Re: Applicant: KARBONSTREAM CORPORATION

FCC ID: N8A26380

Declaration Letter

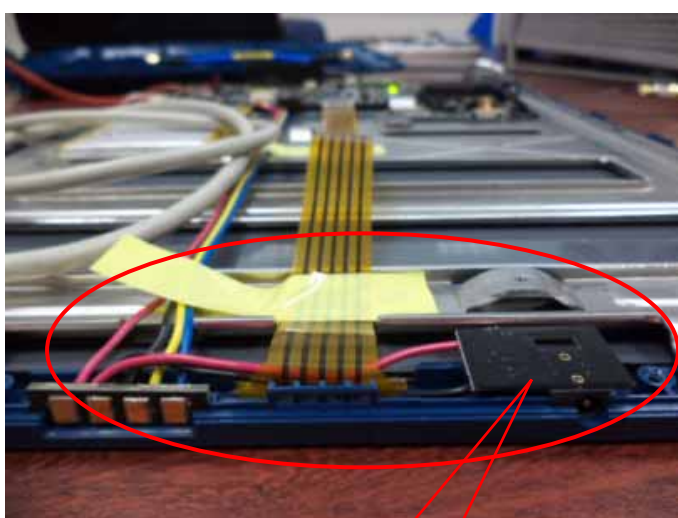
Original	Class II Change
 A photograph of the internal components of a mobile device. The battery is visible on the left, and the main circuit board is in the center. A red circle highlights a small component at the bottom of the board.	 A close-up photograph of the internal components of the modified device. A red circle highlights a parallel DC jack. A red line points from a text box below to this component. <p data-bbox="959 1659 1295 1722">A parallel DC jack</p>

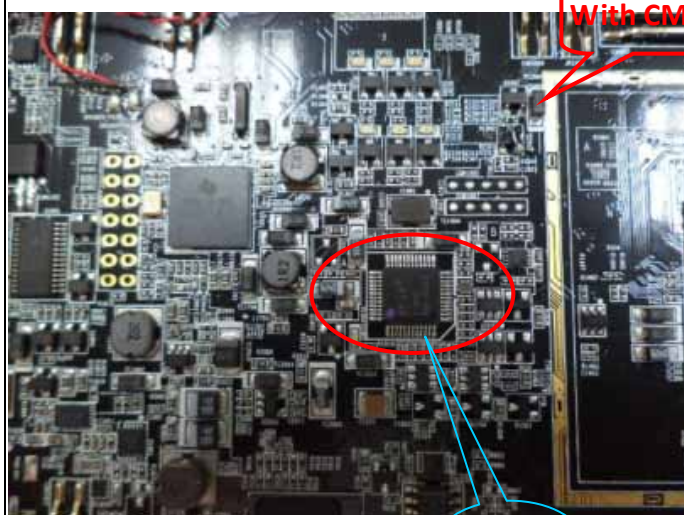
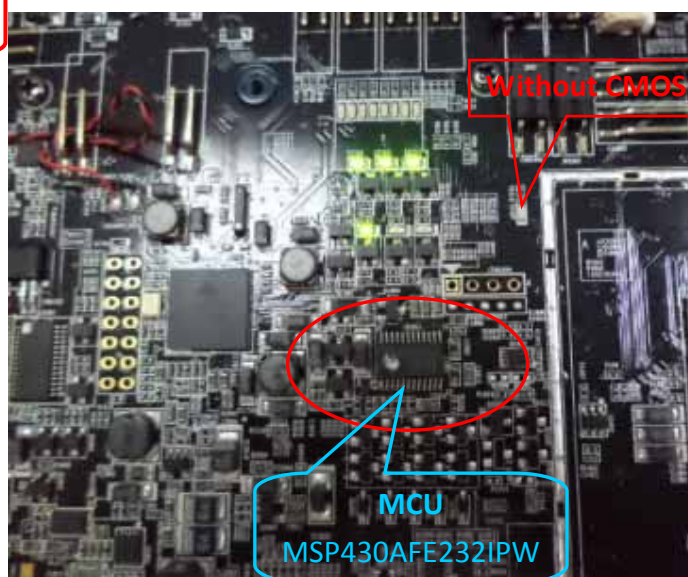
We, KARBONSTREAM CORPORATION request permissive class II change for the KARBONPAS under FCC ID: N8A26380, model name 26380. For this application, 26380 is modified to add a DC jack for extra way charging and to remove CMOS power regulator and changed MCU to MSP430AFE232IPW. Otherwise and WiFi circuits are identical with original's grant. The differences between this application and original's ID as clarified in following pages.

MCU

MCU
MSP430AFE232IPW
